COMMENT FORM

California American Water Company (CalAm) Monterey Peninsula Water Supply Project Draft Environmental Impact Report

THIS COMMENT IS REGARDING THE SLAUT TEST WELL  
PORTION OF THE DEIR, PER SECTION ES-3, SPECIFICALLY  
PAGE ES-5 (SEE ATTACHED) CAL AM WILL OPERATE THE  
TEST WELL FOR UP TO 18 MONTHS, AT WHICH TIME, IF  
THE TEST IS SUCCESSFUL, WILL CONVERT THE WELL

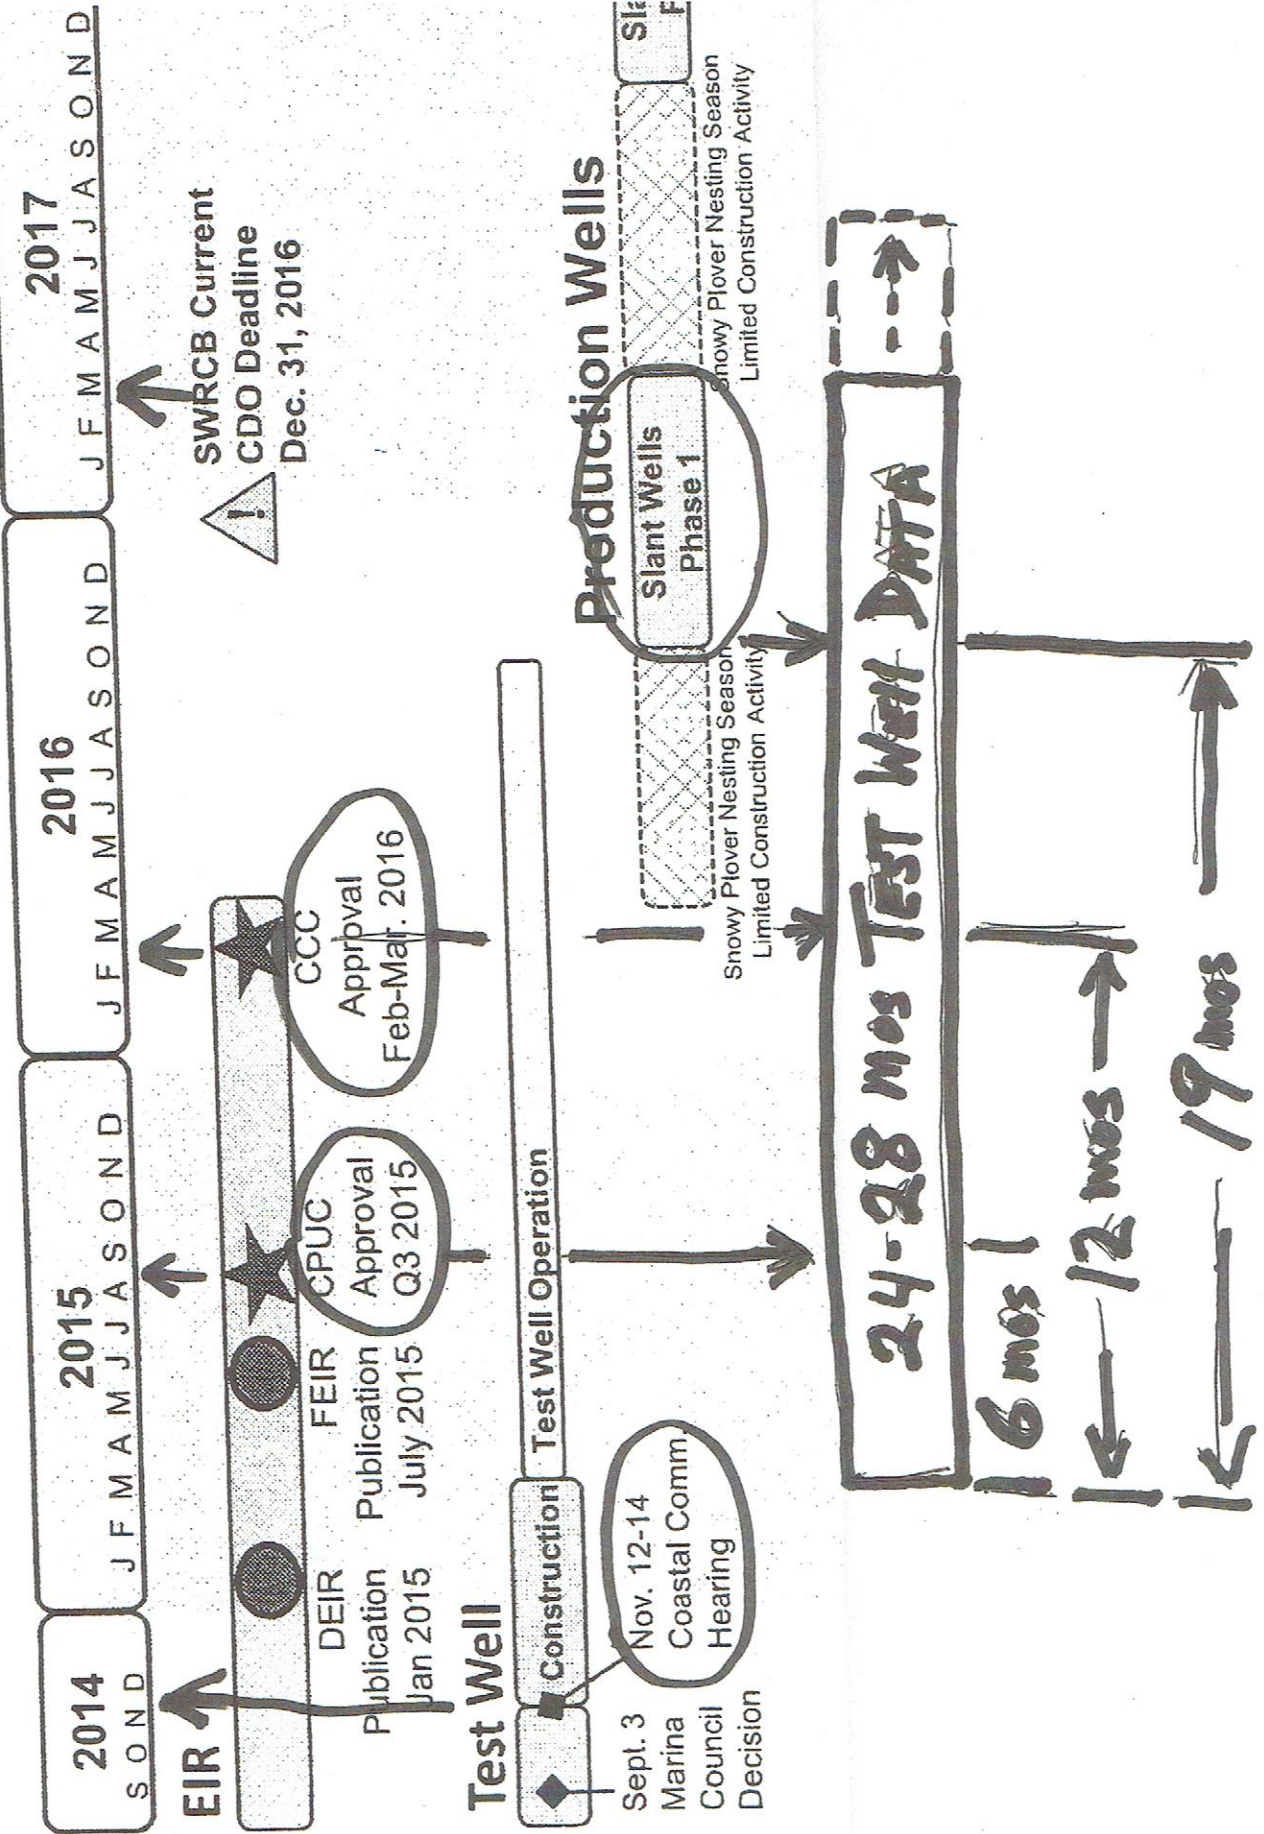
TO A PRODUCTION WELL. ATTACHED ALSO FOR YOUR REVIEW IS A CAL AM SLIDE FROM A RECENT PUBLIC PRESENTATION SHOWING THE TEST WELL CONVERSION.

- 1) HOW DOES CAL AM RECONCILE THE NATURE OF THE TEST WELL IN THE DEIR, WITH THEIR PUBLIC COURT DEFENSE DOCUMENTS?
- 2) HOW DOES THE DEIR CONTAIN A TEST PERIOD OF UP TO 18 MONTHS WHEN THE COASTAL COMMISSION REQUIREMENT WAS NO LESS THAN 24 MONTHS? (SEE ES-5, NOTE 1.)
- 3) THE DEIR STIPUCATES THAT NO WELLS ARE IN EXISTENCE WITHIN 5,000 FEET (SLIGHTLY LESS THAN ONE MILE) AND YET THE FULLY OPERATIONAL AGLAND TRUST WELL IS VISIBLE FROM THE TEST SITE AND ONLY HUNDREDS OF FEET AWAY. HOW DOES CAL AM RECONCILE THIS OBVIOUS, POTENTIALLY FATAL, CERCLA AND SWRCB ERROR?
